How to mount a new model swivel wheel 125x40mm

3041.00.0054

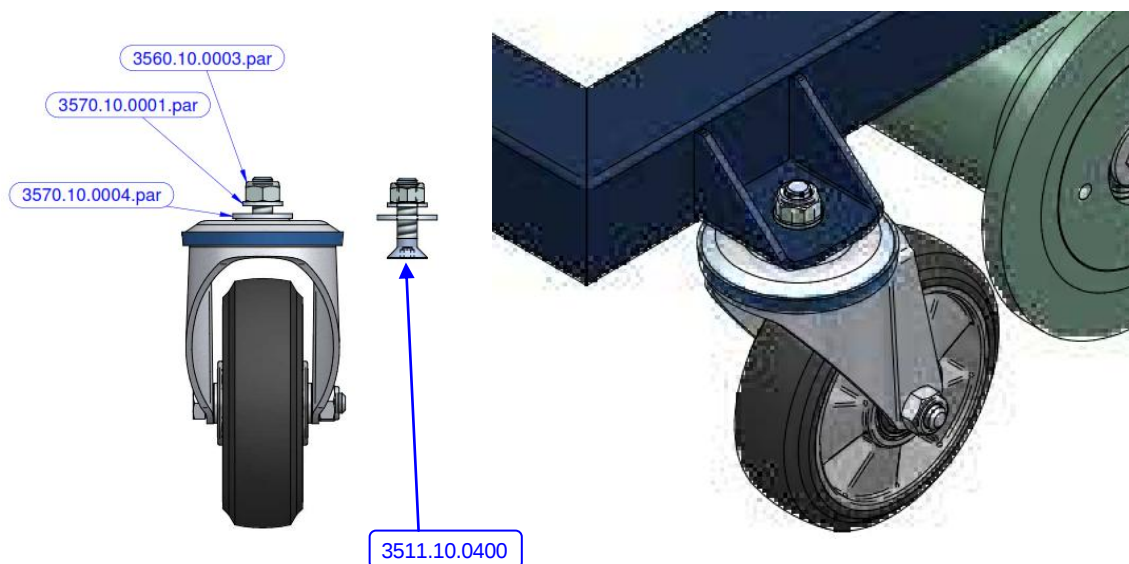
From October 2014 Berg Hortimotive supplied a new type swivel wheel with a larger mounting hole. Therefore it is necessary to use other connecting materials.
 The drawings below shows how the new model wheel should be mounted .

Remove the broken old model swivel wheel:

Install the new model swivel wheel with the indicated connecting materials:

3511.10.0400
 3560.10.0003
 3570.10.0001
 3570.10.0004

countersunk bolt DIN 7991 10.9 M10x40
 locknut DIN 985 8.8 M10
 washer DIN 125A M10
 washer M10x30x2,5
